# M5 Junction 10 Improvements Scheme

## Change Application 2 Change Application Summary Report TR010063 – APP 10.16

#### Change Application 2 Change Application Summary Report

<b>Regulation Number:</b>	N/A
<b>Planning Inspectorate Scheme Reference</b>	TR010063
<b>Application Document Reference</b>	TR010063/APP/10.16
<b>Author:</b>	M5 Junction 10 Improvements Scheme Project Team

Figure 2-2 Link Road cross-section with proposed changes

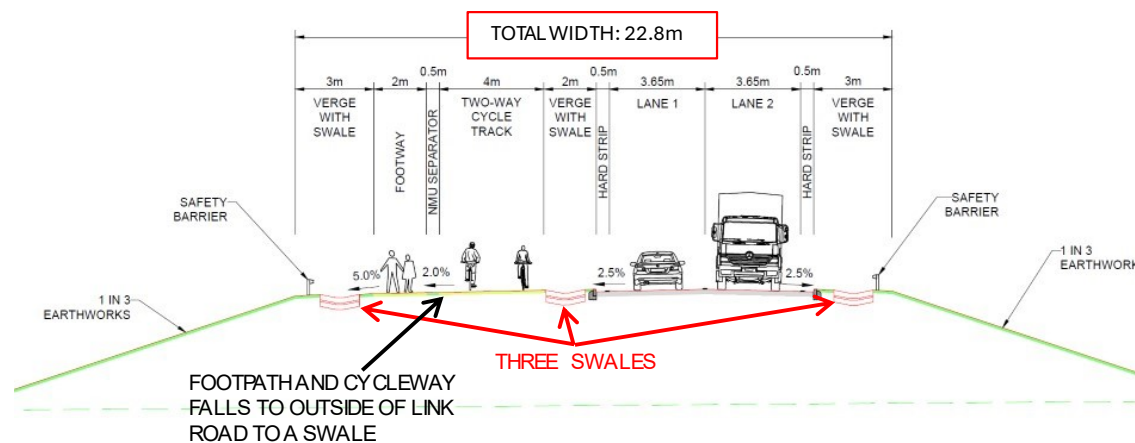
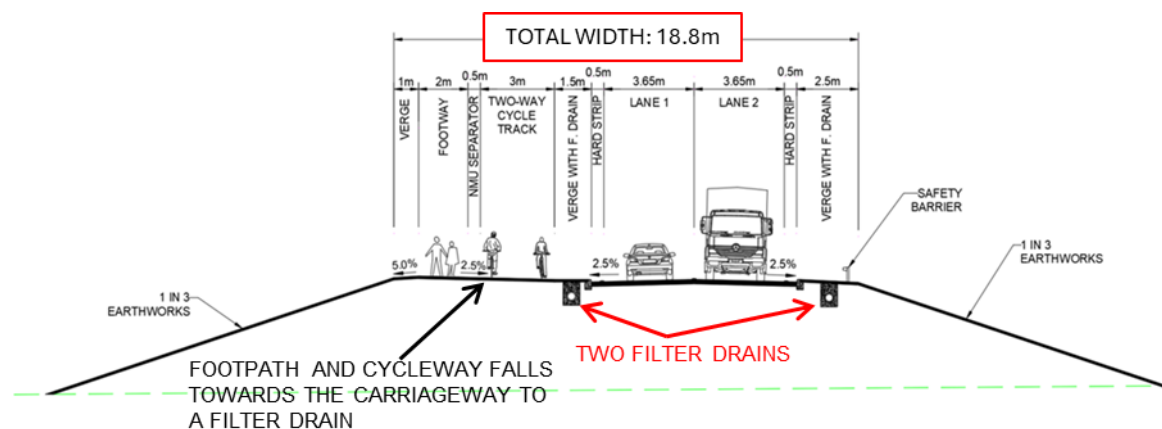
- 2.1.1. The Scheme, as submitted in the DCO Application, currently proposes three swales as the surface water collection method on the Link Road [see Figure 2-1].

- 2.1.2. The Applicant proposes to replace the swales with filter drains. Filter drains provide the following improvements:
- Are narrower than swales, which would allow the width of the Link Road to be reduced. This would decrease the quantity of fill material to be imported, and the footprint of the Link Road in the flood plain.

- 2.1.3. Furthermore, altering the cross-section of the Link Road means that the number of filter drain runs can be reduced from three to two [see Figure 2-2].

Figure 2-4 Elevation of the flood alleviation bridge in the proposed change

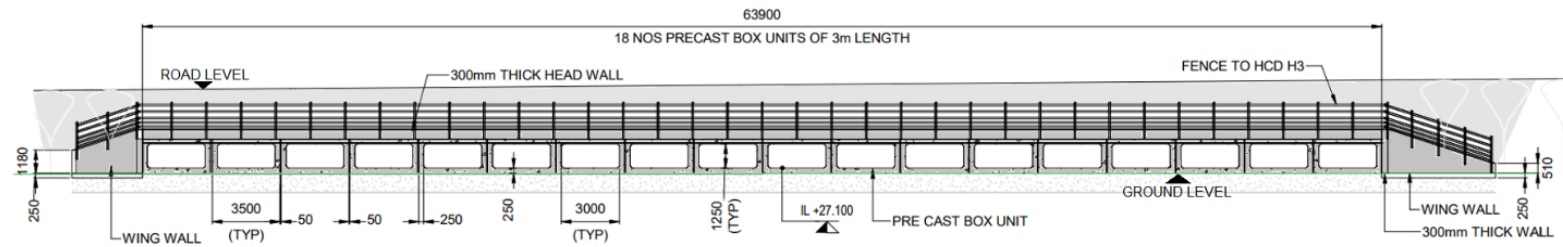
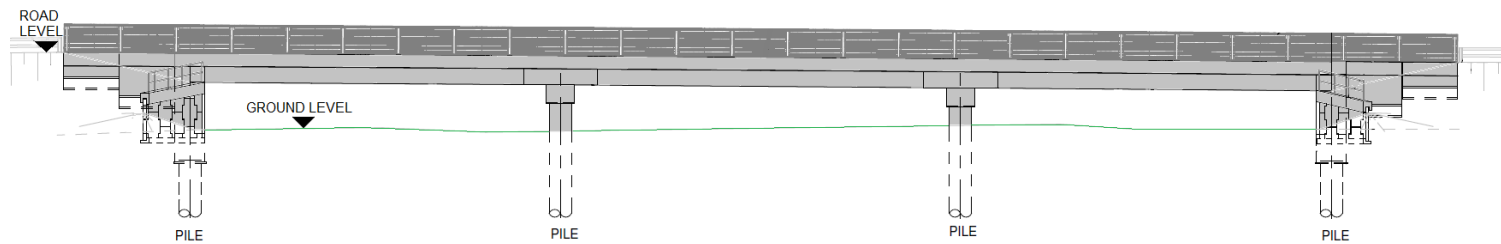
- 2.2.1. The submitted Scheme proposes two flood alleviation structures on the Link Road, to allow flood water to pass under the Link Road [see Figure 2-3]. These structures were to be constructed from rectangular, precast concrete units, to create a series of culverts.

- 2.2.3. The Applicant proposes to change the flood alleviation structures from culverts to bridges [see Figure 2-4]. These bridges would provide the following betterments:

Figure 2-6 Plan of proposed square River Chelt bridge with straighter River Chelt

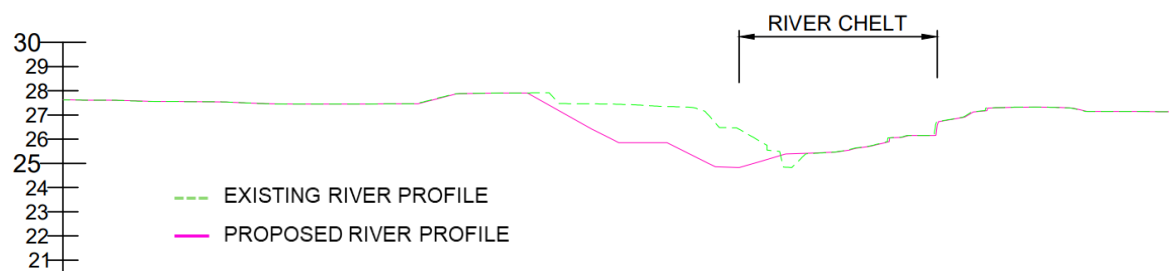
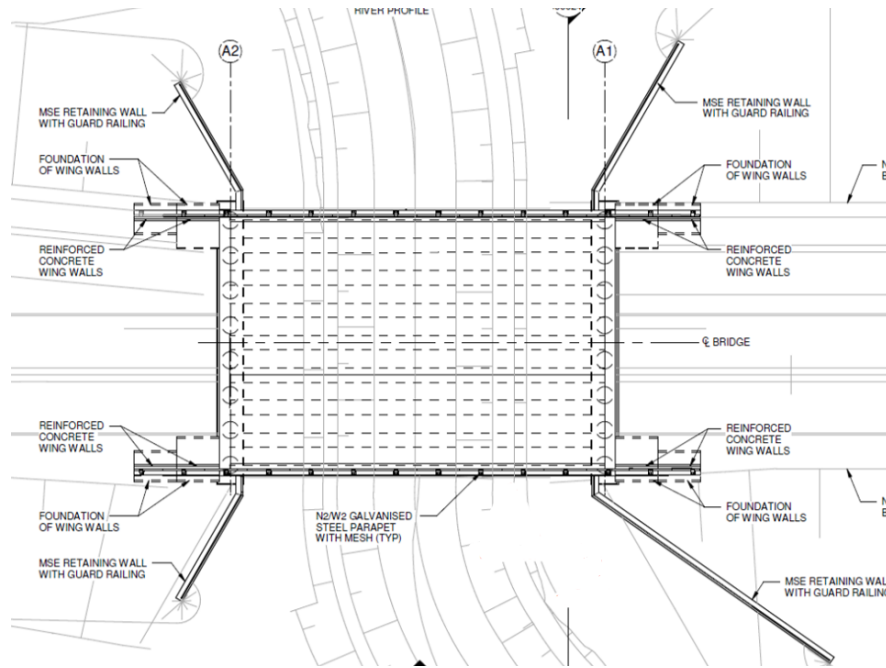
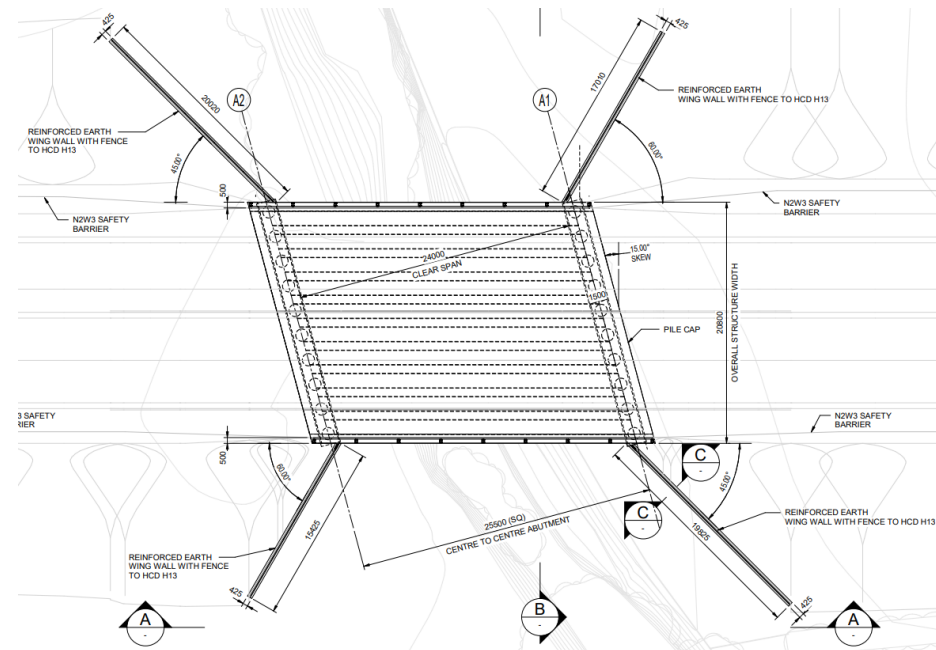
- 2.3.1. The River Chelt bridge proposed in the current Scheme is a skewed structure [see Figure 2-6] with reinforced wing walls and a skewed span of 26.38m. The Scheme design also includes some reprofiling of the existing riverbank to reduce the risk of erosion and create more natural channel profiles [see Figure 2-5].

- 2.3.3. The change is to utilise the requirement for the reprofiling works to straighten the river under the Link Road River Chelt Bridge (to run perpendicular to the Link Road), thereby allowing the installation of a straight (rather than skewed) structure with abutments running perpendicular to the Link Road [see Figure 2-7].

- 2.3.6. A shorter span would result in a reduced beam depth, enabling a reduction in the vertical alignment of the road, in turn reducing the requirement for imported fill material.

Figure 2-8 Link Road plan showing reduced footprint of embankment

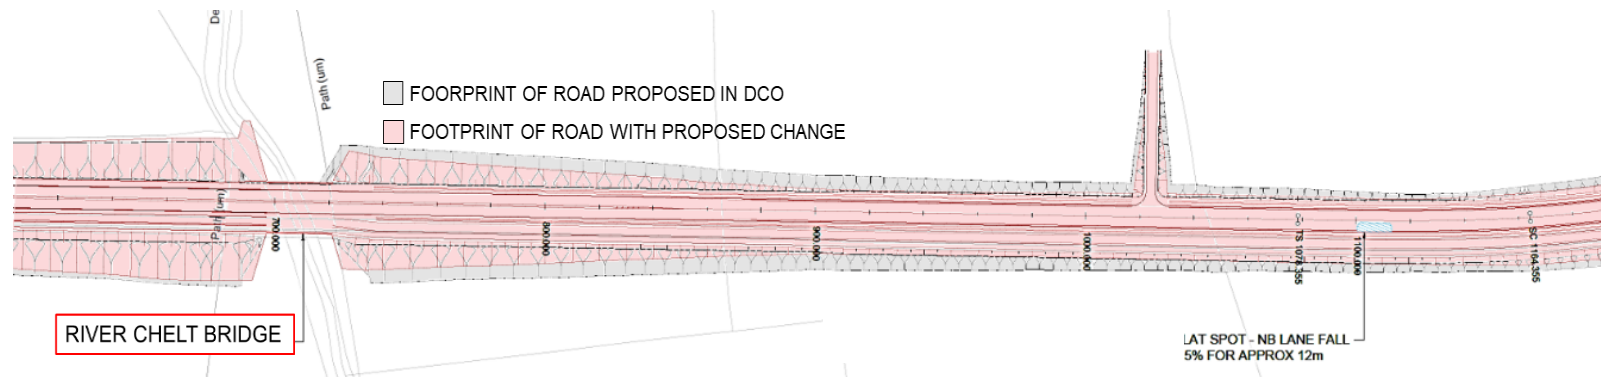
- 2.4.2. The Applicant proposes to optimise the vertical alignment of the Link Road beyond the LoD, by reducing the height of the road by over 1m in localised areas [see Figure 2-9]. This would result in significant reductions in the requirement for imported fill.

- 2.4.3. In addition, the Applicant proposes to reduce the width of the two-way footway cycleway from 4m to 3m to optimise the width of the Link Road [see Figures 2-1 and 2-2]. A review of the potential number of future cyclists identified that a 3m wide cycleway would be more than sufficient for the number of users identified.

Figure 2-14 Location of existing and proposed TS

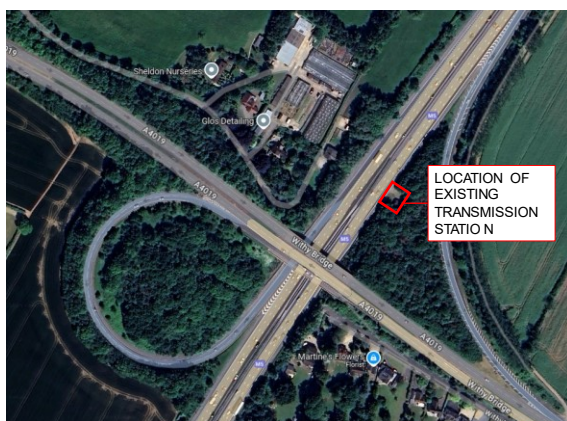
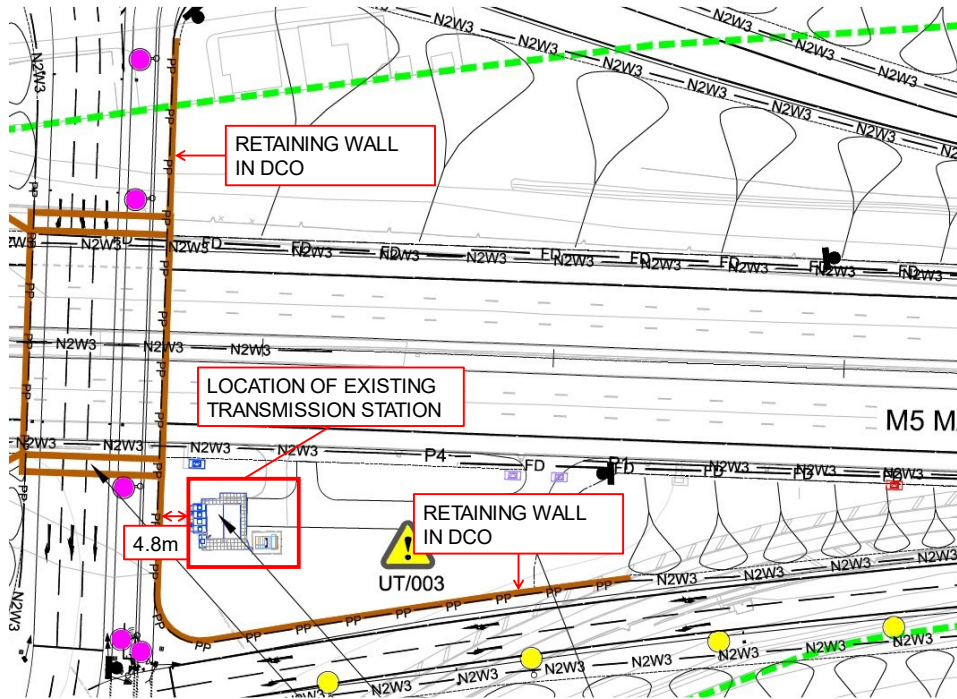
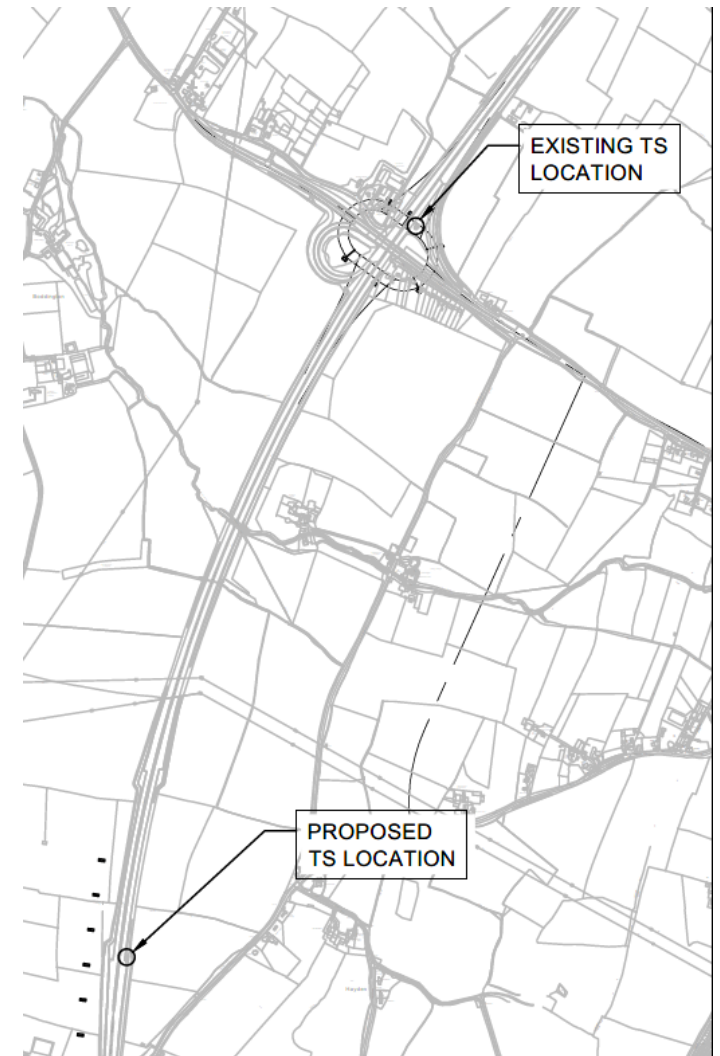
- 2.5.4. For these reasons, it has been determined that the TS needs to be relocated from its current location.
- 2.5.5. The new TS would be modular, similar to that shown in Figure 2-11, with approximate dimensions of 6.7m (L) x 4.8m (W) x 3m (H). The new TS will be located within the Scheme Order limits and highway boundary, approximately 2.6km south of the existing location [see Figures 2-13 and 2-15]. There is existing hardstanding in the verge of the southbound carriageway which would provide a suitable location.

- 2.5.6. Once the TS is relocated, the retaining walls will no longer be required for the Piffs Elm North bridge. As a result, the retaining walls on the north side of the east and west abutments would be replaced with planted embankments.

Figure 2-17 Plan of alternative flood storage area

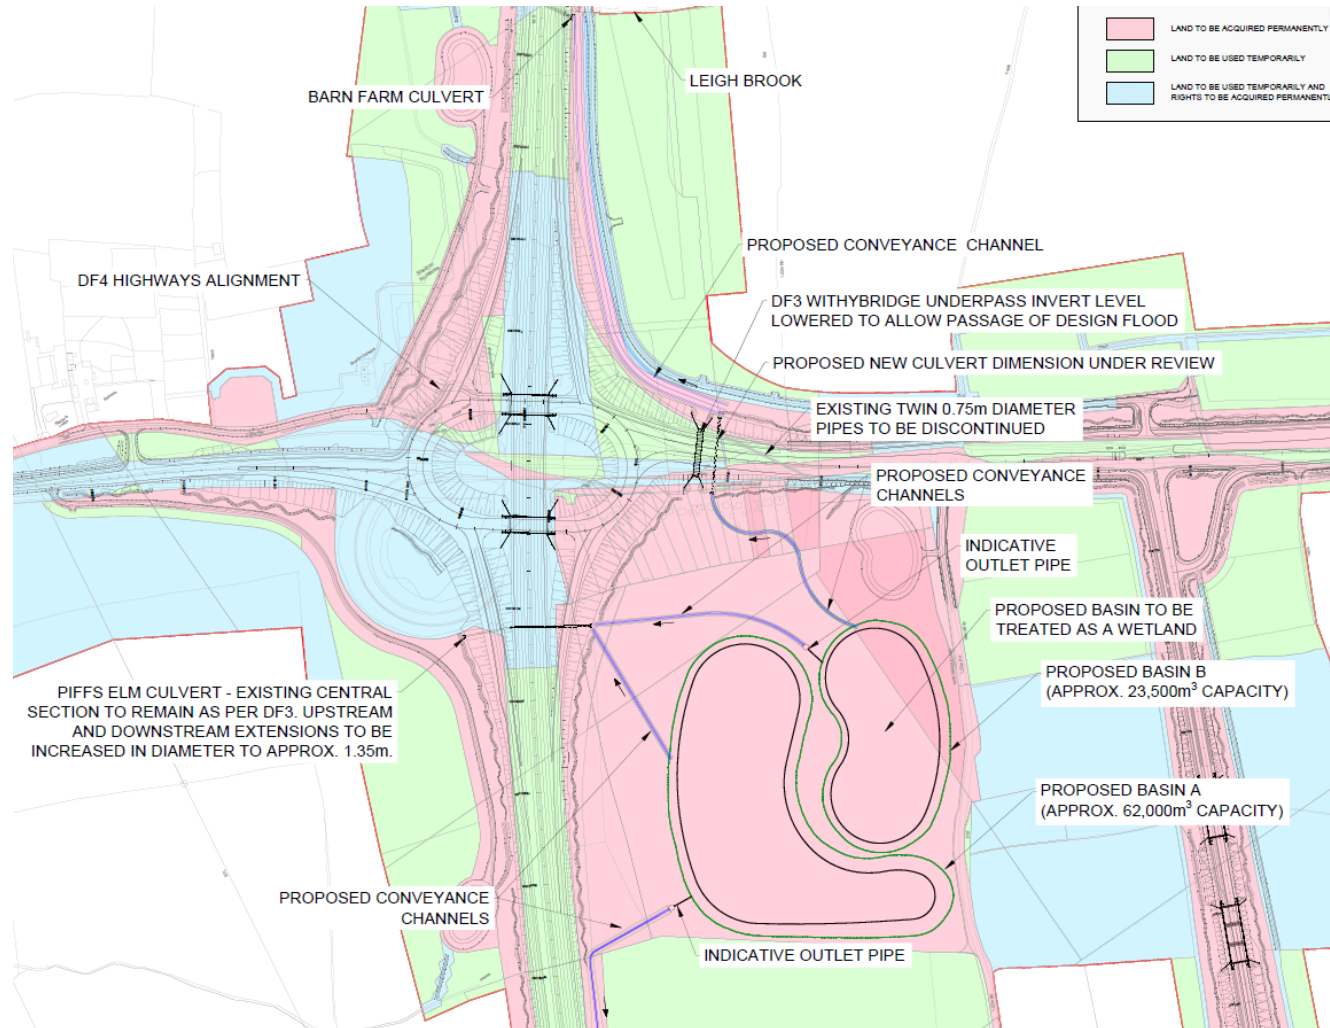
- 2.6.3. The Applicant proposes an alternative flood storage solution which would allow flood waters to flow north of the A4019 and reduce the volume of water that would be stored to the south-east of the Piffs Elm Interchange [see Figure 2-17].

- Withybridge underpass lowered and existing 750mm pipes under A4019 replaced with twin culverts, to provide flood conveyance under the A4019.
- 2.6.5. This solution would not use either the M5 or the A4019 road embankments as impoundment structures for the reservoir. As a result, the solution reduces the maintenance responsibilities (when compared to the Scheme) required under the Reservoirs Act 1975.

Figure 2-18 Location of the infill of the northbound on-slip loop

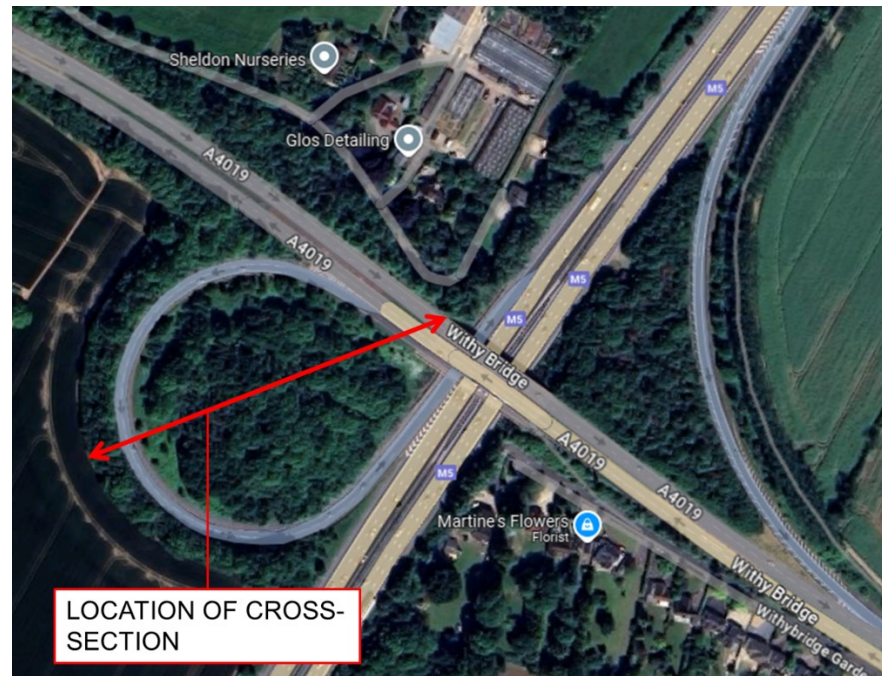
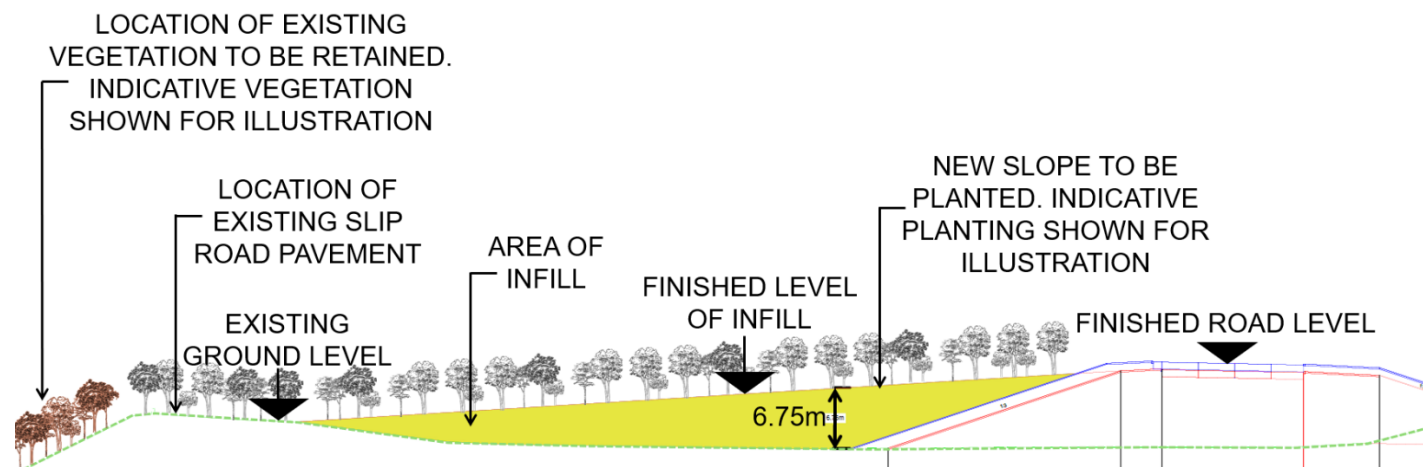
- 2.7.1. The existing M5 J10 northbound on-slip loops onto the M5 carriageway. The current Scheme design proposes to retain the embankment loop in its current form.
- 2.7.2. The Applicant proposes to infill the loop with site won material [see Figures 2-18 and 2-19], which is not suitable to be reused elsewhere, in order to create a new, raised platform to extend woodland planting from the retained vegetation at the outer bank of the existing slip road and provide strengthened screening of the Piffs Elm Interchange.
- 2.7.3. This change would ease the maintenance of the proposed planting as the gradient of the south-west embankment of the Piffs Elm Interchange would be significantly reduced.
